Access Compliance Report Public Rights-of-Way (Curb Ramps)

Main Street: HILLVIEW_RD Cross Street: ORANGE_AVE Location: NE

ADA ID: RPAT211130143941 Ramp Type: Type 4 - Parallel Initial Pass/Fail: Fail Overall Compliance: No Severity Score: 15

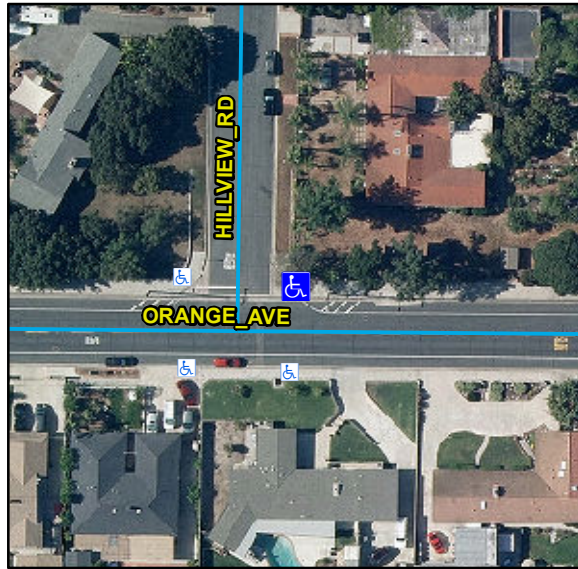
Compliance	Description	Data	Compliance	Description	Data
N/A	Ramp Length LT (in)	87	N/A	Ramp Length RT (in)	87
Yes	Ramp Width LT (in)	99	Yes	Ramp Width RT (in)	96
Yes	Ramp Run Slope LT (%)	6.4	Yes	Ramp Run Slope RT (%)	6.1
No	Ramp Cross Slope LT (%)	3.4	No	Ramp Cross Slope RT (%)	6
N/A	Landing Present	N/A	N/A	DWS Provided	N/A
N/A	Landing Length (in)	N/A	N/A	DWS Contrast	N/A
N/A	Landing Width (in)	N/A	N/A	DWS Length (in)	N/A
N/A	Landing Run Slope (%)	N/A	N/A	DWS Full Width	N/A
N/A	Landing Cross Slope (%)	N/A		DWS Offset Type	N/A
N/A	Landing Movement Obstructed?	N/A	N/A	DWS Offset Left (in)	N/A
	Landing Movement Type	N/A	N/A	DWS Offset Right (in)	N/A
N/A	Landing Shared	N/A			
N/A	Clear Space	Yes			
N/A	Clear Space To Crosswalk (in)	N/A			
N/A	Marked Crosswalk 1	No	N/A	Marked Crosswalk 2	No
	Crossing 1 Direction	W		Crossing 2 Direction	S
	Marked Crosswalk 1 Width (in)	N/A		Marked Crosswalk 2 Width (in)	N/A
N/A	Ramp Inside Crosswalk 1	N/A	N/A	Ramp Inside Crosswalk 2	N/A

Remove & Replace Curb Ramp With Two New Directional Ramps or Equivalent.

R304.5.3, STD 1115
